Docket No. 50-423
B13164

Attachment 1

Millstone Nuclear Power Station, Unit No. 3
Proposed Revision to Technical Specifications

April 1989

Figure 3.9-1

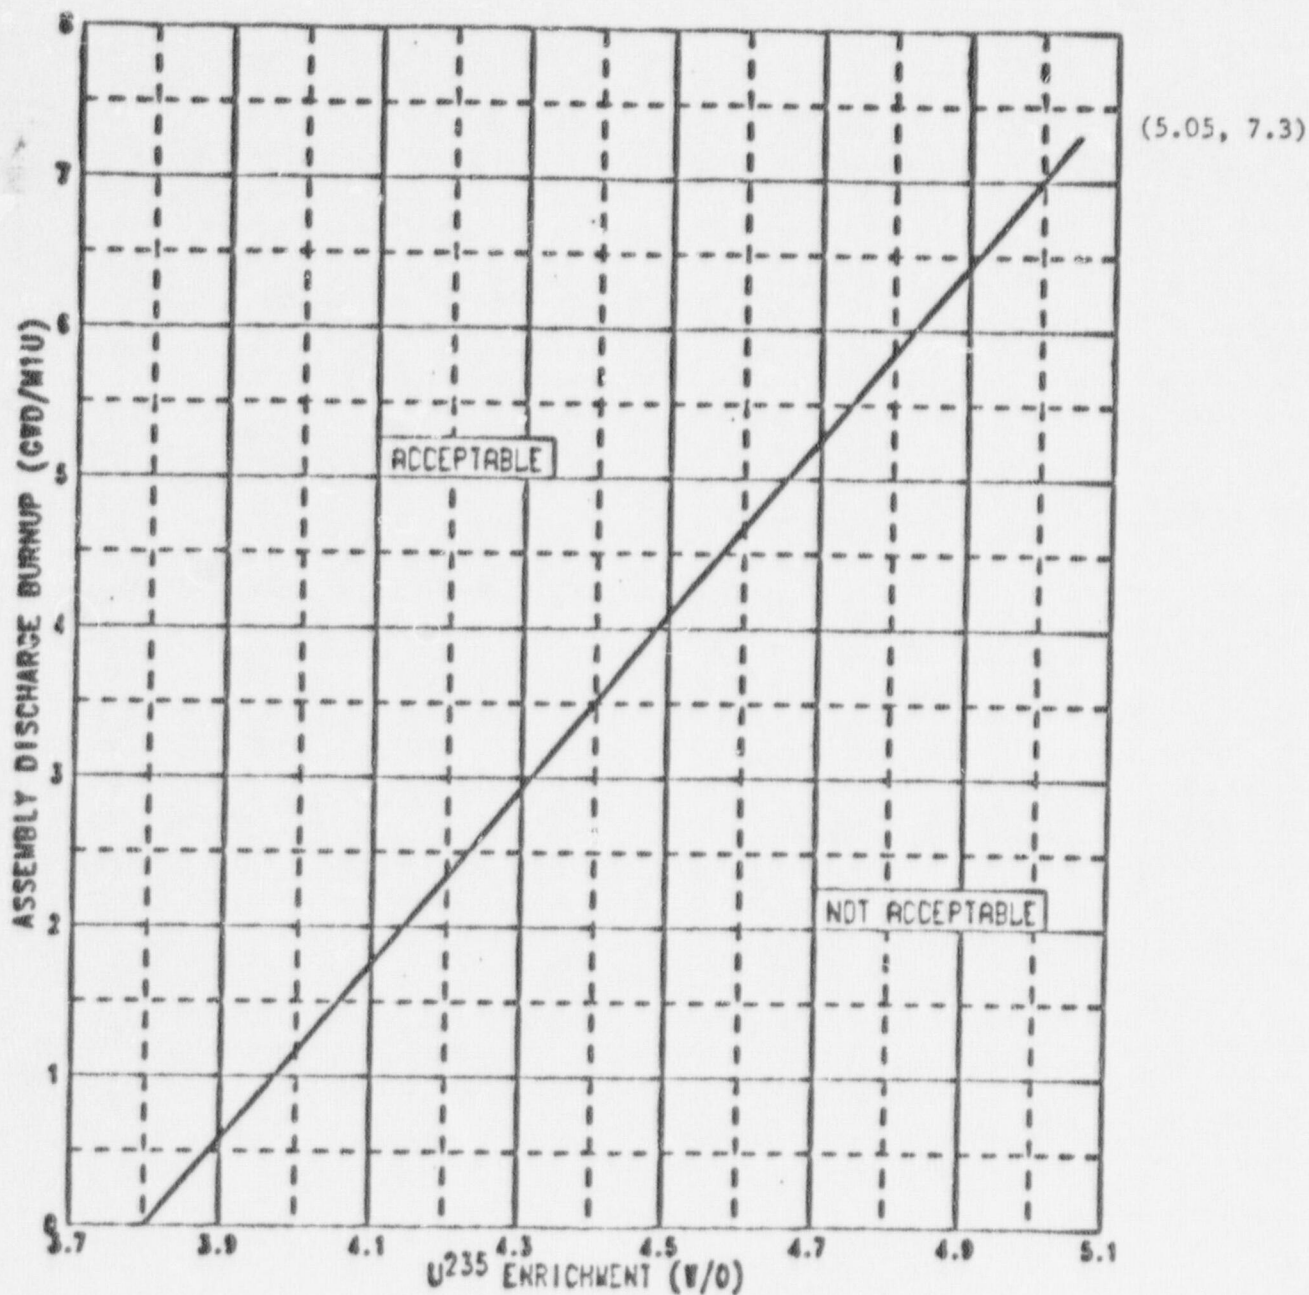
4.9.13 Ensure that all fuel assemblies to be placed in Region II of the spent fuel pool are within the enrichment and burn-up limits of Figure 3.9-1 by checking the fuel assembly's design and burn-up documentation.

The limitations described by Figure 3.9-1 ensure that the reactivity of fuel assemblies introduced into Region II are conservatively within the assumptions of the safety analysis.

- d. Fuel assemblies stored in Region II of the spent fuel pool may have a maximum nominal fuel enrichment of up to 5.0 weight percent, conditional upon compliance with Figure 3.9-1 to ensure that the design burnup of the fuel has been sustained.

Figure 3.9-2

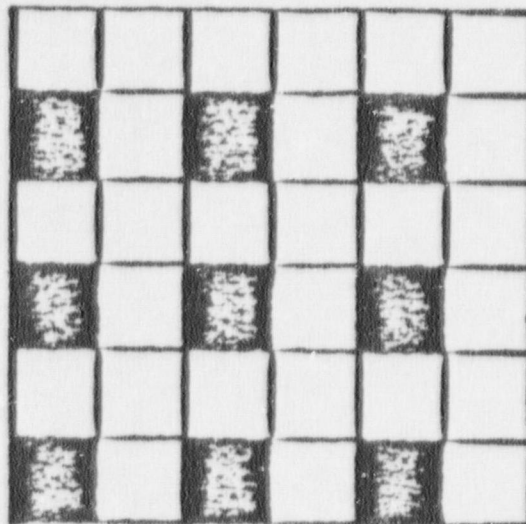
1.40 Region I spent fuel racks contain a cell blocking device in every 4th location for criticality control. This 4th location will be referred to as the blocked location. A STORAGE PATTERN refers to the blocked location and all adjacent and diagonal Region I cell locations surrounding the blocked location. Boundary configuration between Region I and Region II must have cell blockers positioned in the outermost row of the Region I perimeter, as shown in Figure 3.9-2.

- a. Prior to storing fuel assemblies in the STORAGE PATTERN per Figure 3.9-2, the cell blocking device for the cell location must be installed.
- b. Prior to removal of a cell blocking device from the cell location per Figure 3.9-2, the STORAGE PATTERN must be vacant of all stored fuel assemblies.

STORAGE PATTERN for the Region I storage racks will be established and expanded from the walls of the spent fuel pool per Figure 3.9-2 to ensure definition and control of the Region I/Region II boundary and minimize the number of boundaries where a fuel misplacement incident can occur.

- c. Fuel assemblies stored in Region I of the spent fuel pool may have a maximum nominal fuel enrichment of up to 5.0 weight percent U_{235} ; Region I is designed to permit storage of fuel in a 3-out-of-4 array with the 4th storage location blocked as shown in Figure 3.9-2.

FIGURE 1

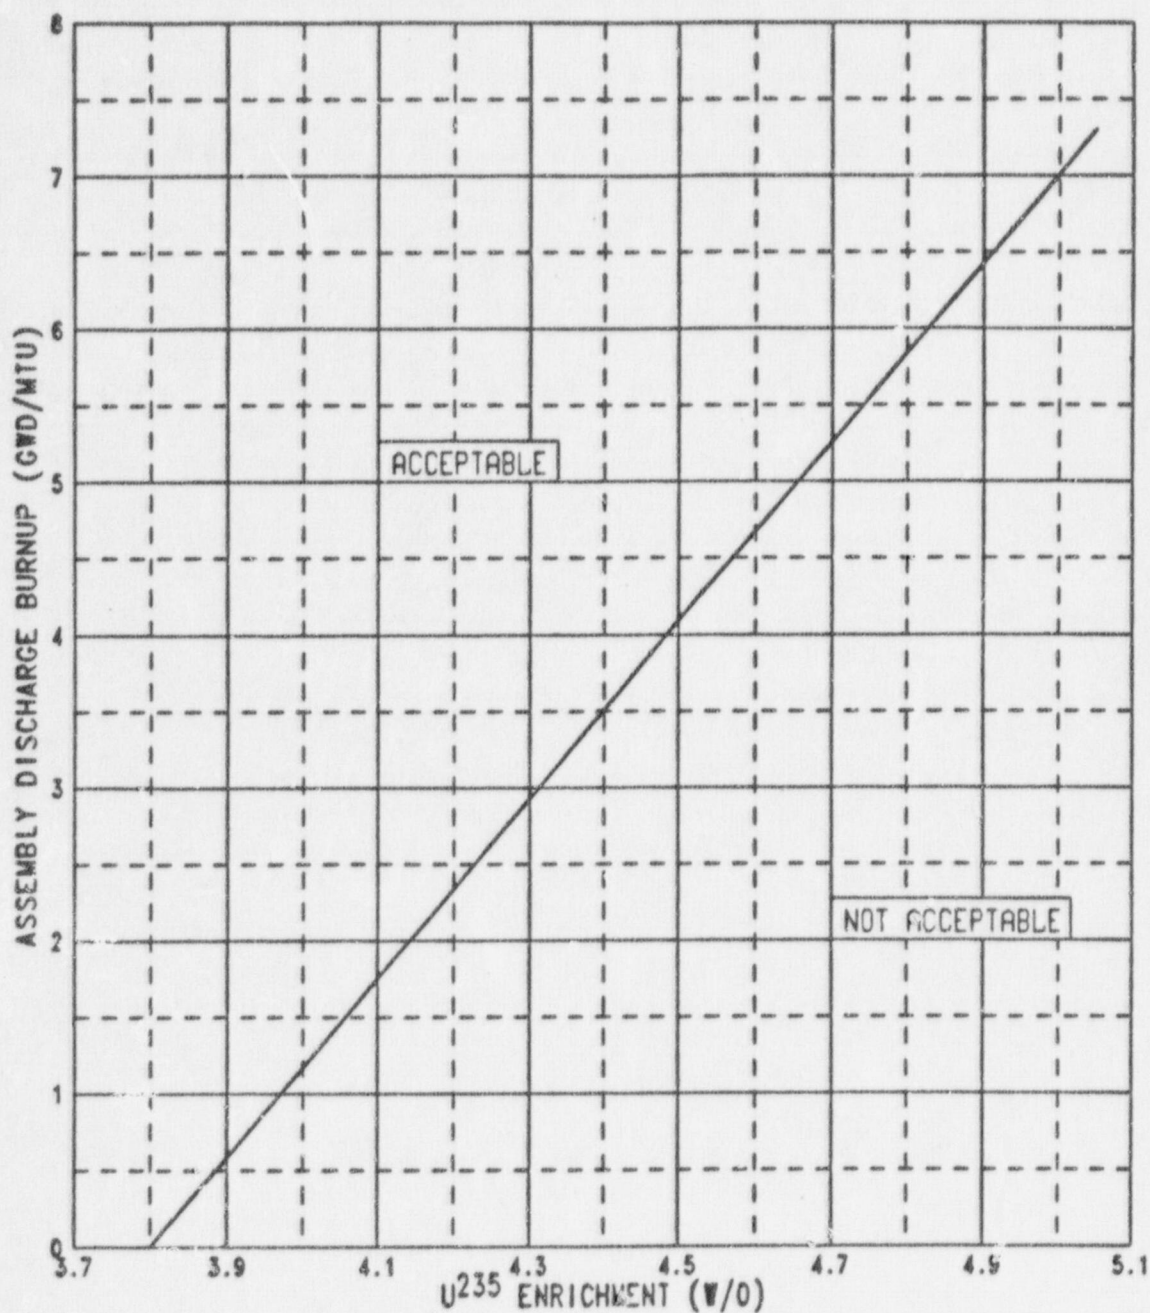
The Region I rack reanalysis was based on maintaining K_{eff} less than or equal to 0.95 for storage of Westinghouse 17 x 17 OFA and STD fuel at a nominal 5.0 w/o U-235 utilizing three-out-of-four storage cells in the array. The Region II spent fuel rack reanalysis was based on maintaining K_{eff} less than or equal to 0.95 for storage of Westinghouse 17 x 17 OFA and STD fuel at a nominal 5.0 w/o U-235 with an initial enrichment/burnup combination in the acceptable area of Figure 1 with utilization of every cell permitted for storage of the fuel assemblies.

The nominal and maximum K_{eff} for storage of spent fuel in Region II was determined as described below. The actual conditions for this determination are defined by the zero burnup intercept point in Figure 1. The KENO-IV computer code was used to calculate the storage rack multiplication factor with an equivalent fresh fuel enrichment of a nominal 3.85 w/o. Combinations of fuel enrichment and discharge burnup yielding the same rack multiplication factor as at the zero burnup intercept are determined with PHOENIX.
